Permit Number: 070625

has permission to New 20 unit Residential & associated site improvements

AT 55 SMITH ST

RE: Bayside East, Proposed Elderly Housing, 47 Smith Street

1 BASEMENT FLOOR REVISED STAIR PLAN
1/4" = 1'-0"

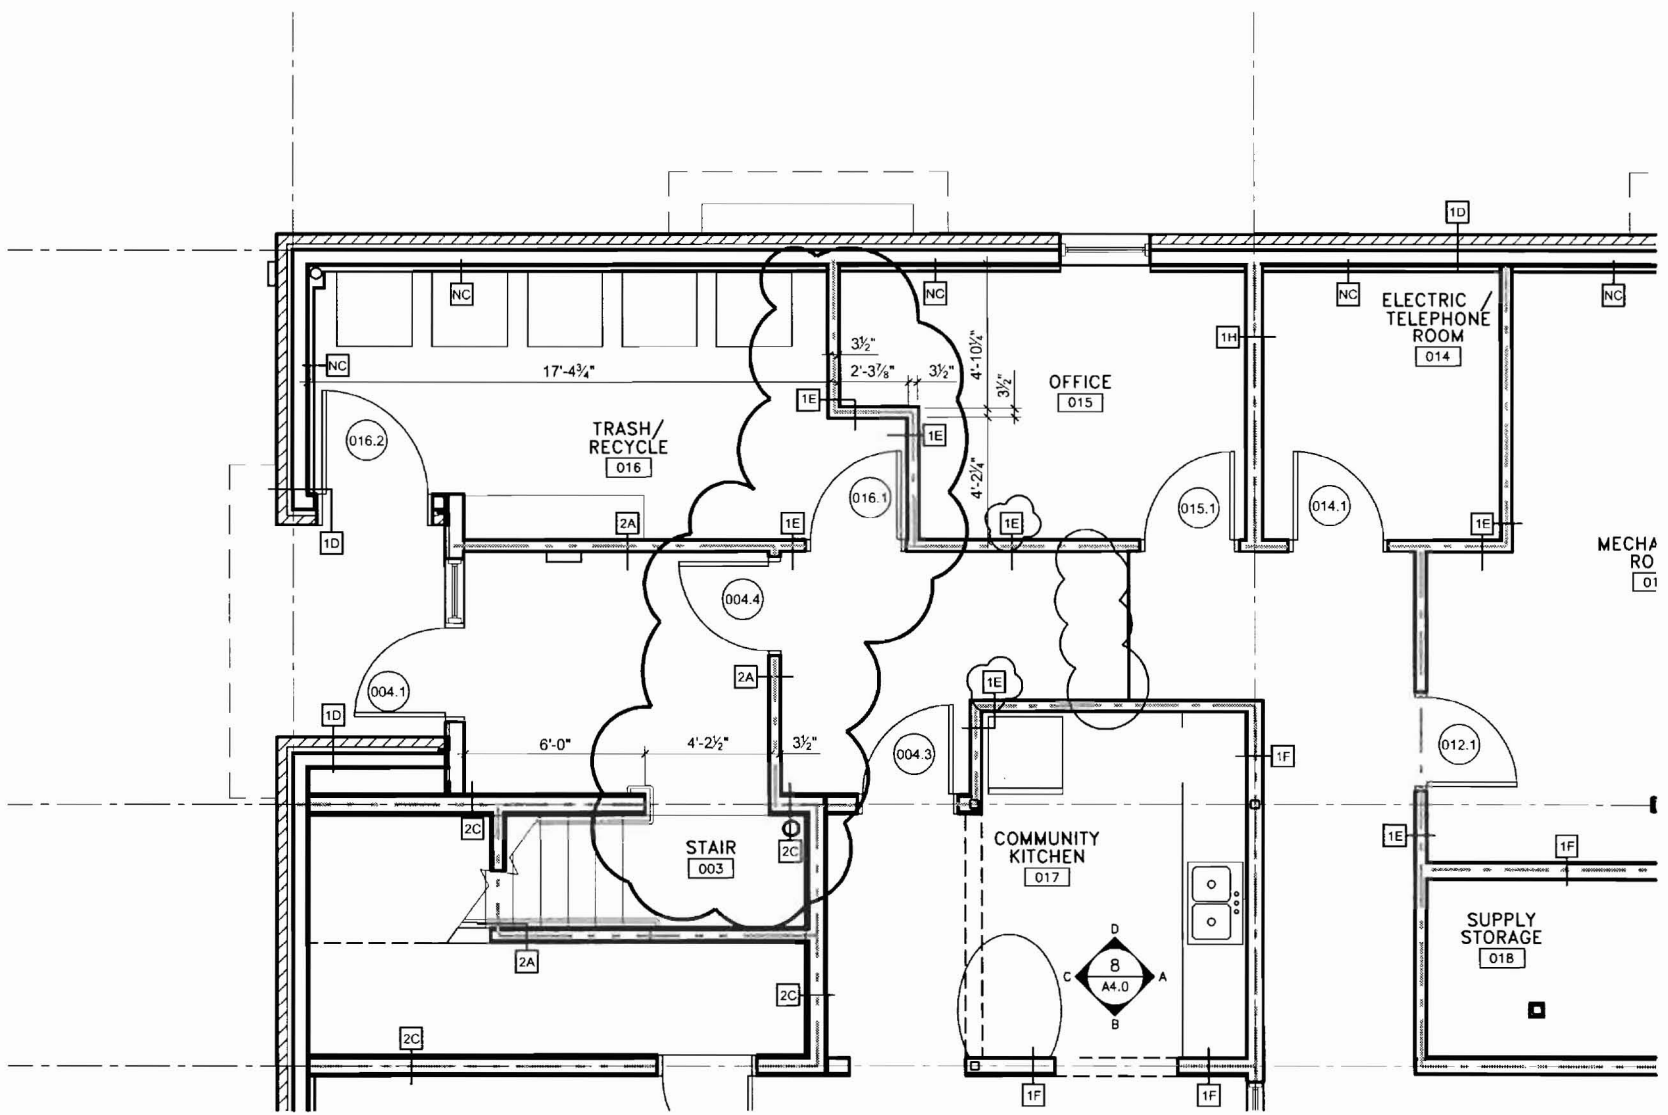
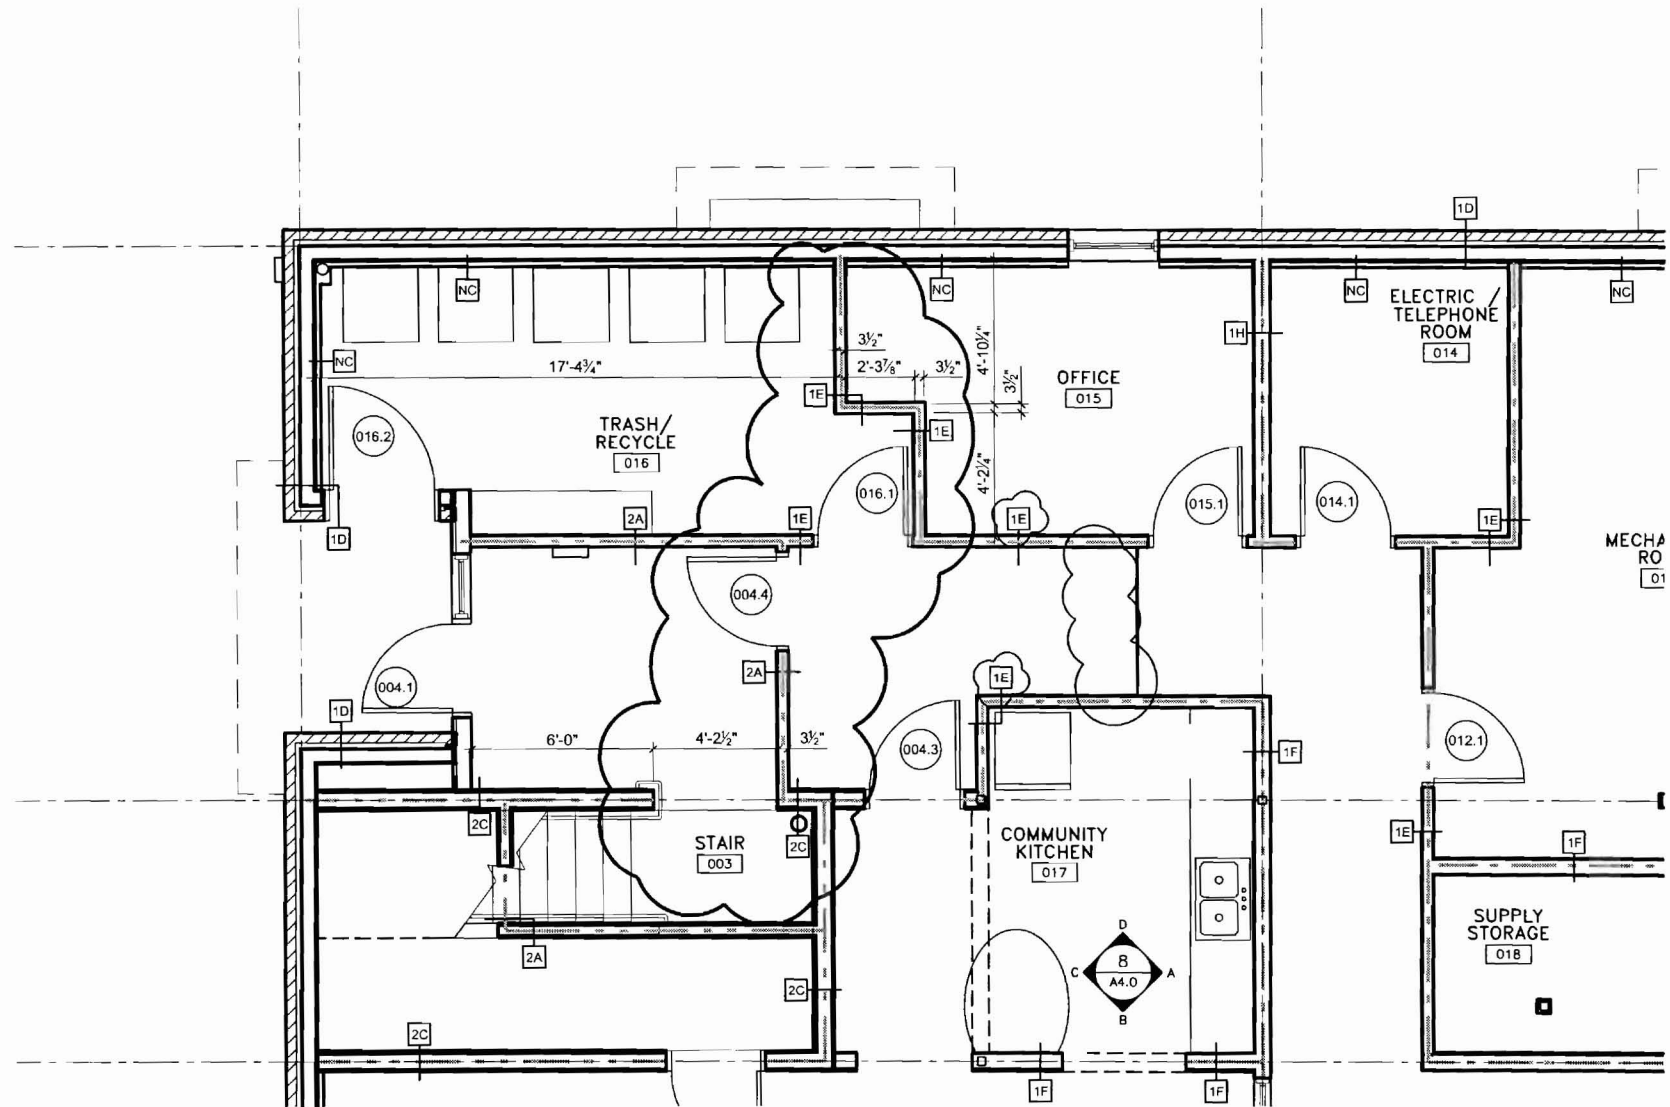
CRITICAL ITEM: It looks like both means of egress discharge into a "Vestibule" This seems to exceed the 50% rule commonly associated with vestibule use. Please provide a code justification.

CRITICAL ITEM: It looks like both means of egress discharge into a "Vestibule" This seems to exceed the 50% rule commonly associated with vestibule use. Please provide a code justification.

- 1.) See the attached ASK-1 and ASK-2 making the stair directly exit onto the sidewalk.
- 2.) The basement level of the building is considered a basement per the definition of a basement in IBC 2003 section, 502.1, it is not more than 6 ft above the grade plane, it is not more than 6 ft above the grade plane for more than 50% of the building, is not more than 12 ft above finished ground at any point.

- 1.) See the attached ASK-1 and ASK-2 making the stair directly exit onto the sidewalk.
- 2.) The basement level of the building is considered a basement per the definition of a basement in IBC 2003 section, 502.1, it is not more than 6 ft above the grade plane, it is not more than 6 ft above the grade plane for more than 50% of the building, is not more than 12 ft above finished ground at any point.
